PROJECT: First Financial Bank
Fourth Floor Finish Out

ADDENDUM

Number: FIVE

MMS-AE SD06R

NEW CEILING ON THIRD FLOOR
SCALE: 1/8"=1'-0"

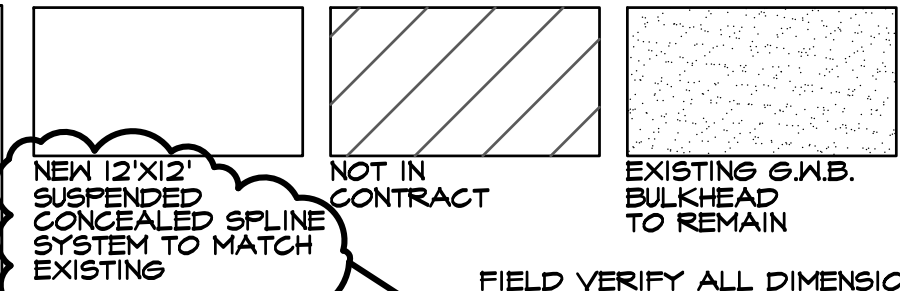
REVISION PER OWNER'S REQUEST:

REMOVE EXISTING CONCEALED SPLINE CEILING TILES IN AREA TO RECEIVE NEW 12'X12' CONCEALED SPLINE CEILING COMPLETE TO ACCOMMODATE ANY MECHANICAL, ELECTRICAL, IT, VOICE COMMUNICATION, AND/OR PLUMBING WORK ON THE FOURTH FLOOR.

REPLACE WITH NEW 12'X12' SUSPENDED CONCEALED SPLINE CEILING SYSTEM TO MATCH EXISTING. FIELD VERIFY FOR MATCH AND SUBMIT FULL RANGE TO ARCHITECT. USE 'ARMSTRONG' FISURED OR EQUAL.
